4. TITLE (and Subtitle) Phase I Inspection Report National Dam Safety Program, Lake Fairfax Dam Fairfax County, Seawater Virginia		5. TYPE OF REPORT & PERIOD COVERED Final rept.

Name of Dam: Lake Fairfax Dam
State: Virginia
County: Fairfax
USGS 7.5 Minute Quadrangle: Vienna, VA-MD
Stream: Colvin Run
Date of Inspection: 15 April 1980

BRIEF ASSESSMENT OF DAM

PHOTO 1. Principal Spillway Intake and Controls for Emergency Gate

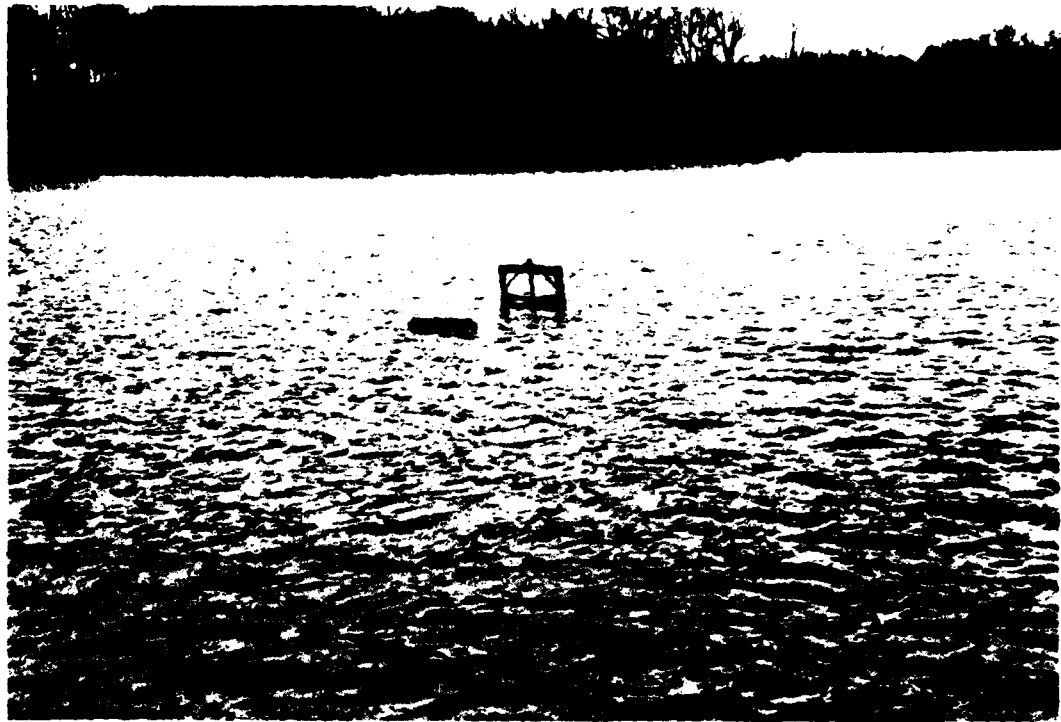
There is an emergency gate, but there is no information available on the size or type of gate. The gate is controlled by a stem which rises above normal pool just upstream of the principal spillway intake. The controls for the gate appear to be in poor condition; according to the owner, the gate is no longer operable.

- 8) The emergency gate should be repaired and maintained in an operable condition.

PHOTO 5. Inadequate Riprap and Erosion of Embankment Adjacent to Right Training Wall of Emergency Spillway Approach Channel

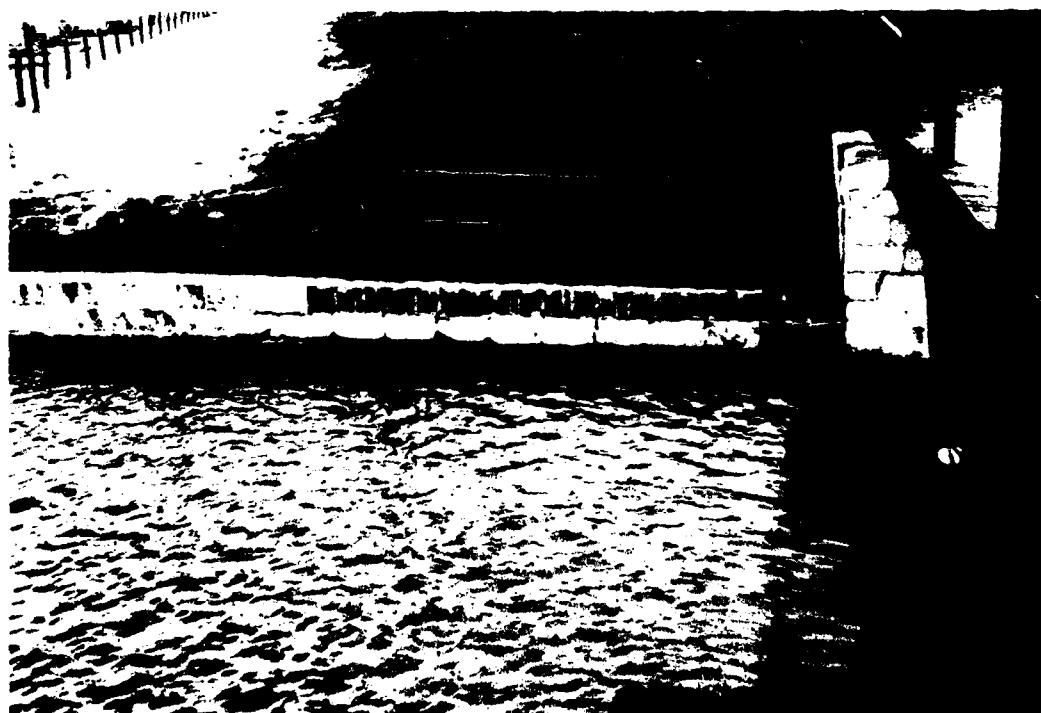
- 3) Additional riprap should be placed on the left side of the upstream embankment adjacent to the right training wall of the emergency spillway approach channel.
